TECHNICAL SERVICE BULLETIN

BULLETIN NUMBER: G130/G131 - 006 **05/09/2006**

SUBJECT: CONTROLLER BOARD

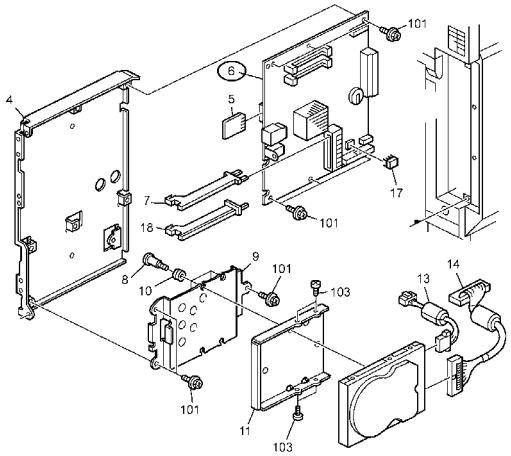
To ensure the heat sink stays properly attached to the controller board, the attachment method for the heat sink on the controller board CPU has been changed. The following updated part information is being issued for all G130/G131 Parts Catalogs. Please update your parts catalog with the following information.

REFERENCE	
OLD PART NO.	NEW PART NO.	DESCRIPTION	QTY	INT	PAGE	ITEM
G1305791	G1305794	Controller Board – G130	1	-	87	6
G1315791	G1315794	Controller Board – G131	1	-	87	6
